TOWN OF PLAINFIELD DESIGN REVIEW COMMITTEE REPORT - REVISED

DATE: 12-07-2023
CASE NO.: [Not Docketed](#)
PETITIONER: Innovative Engineering
REQUESTED ACTIONS: Development Plan Amendment - Architectural and Site Design Review for a façade renovation and 26,000 sq ft building expansion
Waivers – Building Materials
Development Incentives – Orientation of Loading Spaces

LOCATION: 2733 E. Main St.
PARCEL SIZE: 25 acres+/-

Current Site

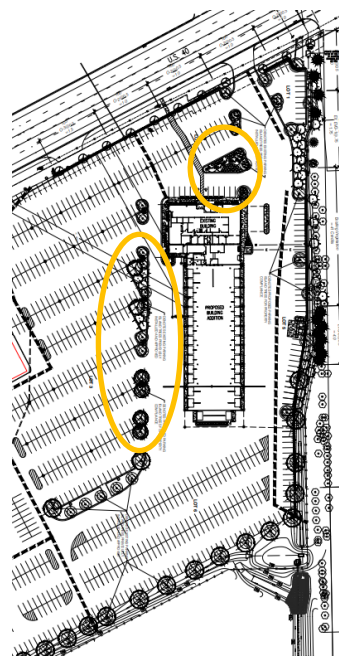
The site plan includes landscape island removal along the east side of the building as shown in yellow below. The landscape plan includes an expanded landscape island on the north side of the building. The petitioner has requested a Development Incentive to allow the overhead doors to face Main Street, and new and expanded islands have been added to provide screening.
